APPENDIX-14 S-1 ANNUAL OVERHAULING ACTIVITIES

**SUBJECT: JICA Mission Recommendation/Comments
on Forthcoming S - 1 Overhauling**

SUBJECT : S - 1 Annual Overhauling Activities

JICA MISSION RECOMMENDATION/COMMENTS
ON S-1 OVERHAULING ACTIVITIES

FIG I

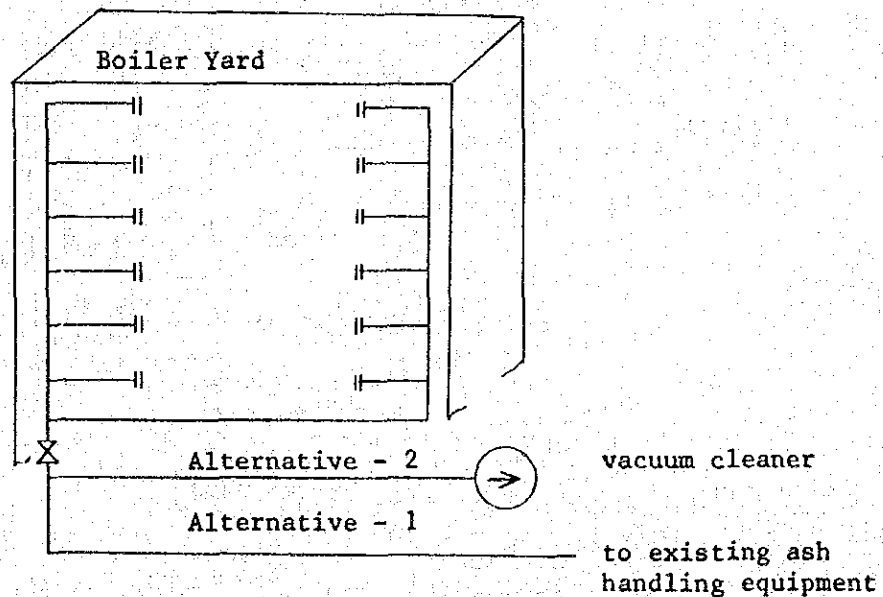
- 1) Re-check of all spare parts required for replacement of defective equipment. Purchase spare parts if not available.
- 2) Installation of additional temporary lifting equipment for smooth and quick transfer/movement of materials and tools during overhauling.
- 3) Permanent installation of vacuum cleaner connection on each floor of boiler (yard) area to clean all equipment.

Repair the existing ash handling equipment and connect the cleaning line to be additionally installed with the existing vacuum piping as shown in Figure I.

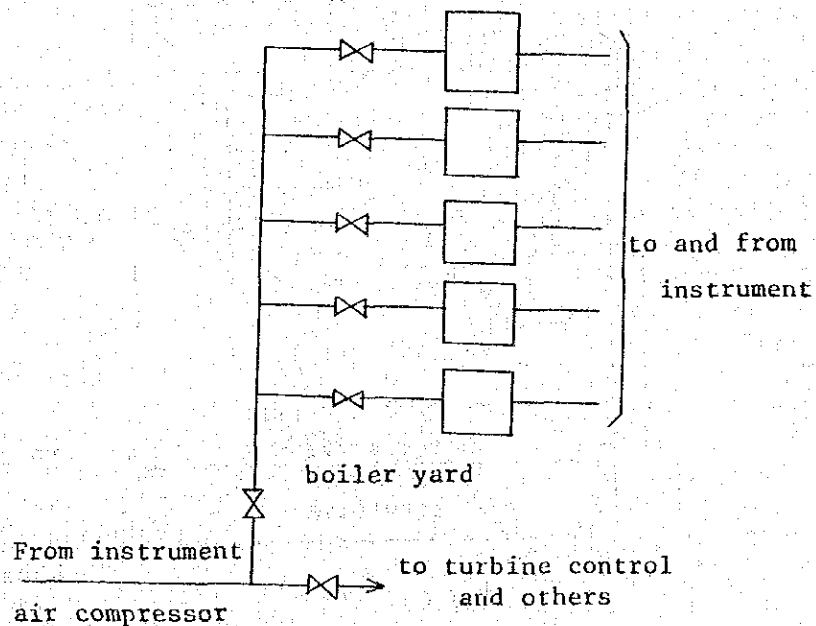
- 4) A large volume of gas leak from the boiler casing particularly on the 10th and 11th floor.

The ambient temperature is very high (about 50°C) and nobody can withstand the heat for a minimum period of 10 minutes. One factor causing this condition is the insufficient ventilation in this area. Boiler casing should be perfectly repaired for the health of plant personnel and effectiveness in performing operation, preventive maintenance, inspection and overhauling activities.

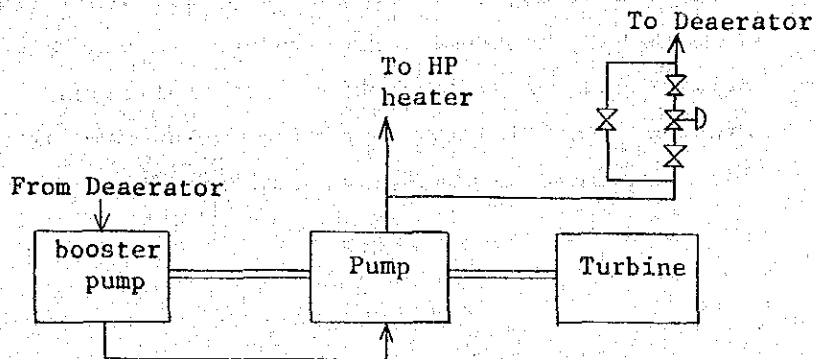
Blowing out/purging of instrument air pipings for control units including locally mounted control units is required for satisfactory operation of automatic controls. For long-term rehabilitation, instrument air piping should be modified as follows:

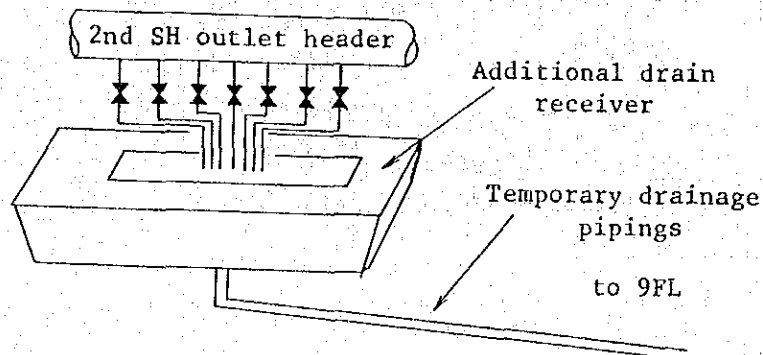
- 4) Wire for solenoid valve of turbine-driven BFP minimum flow control valve is not connected, and BFP-T is operated keeping fully opened. This valve should be replaced with hydraulic-actuated valves, and by-pass valve and isolating should be at least installed as follows:
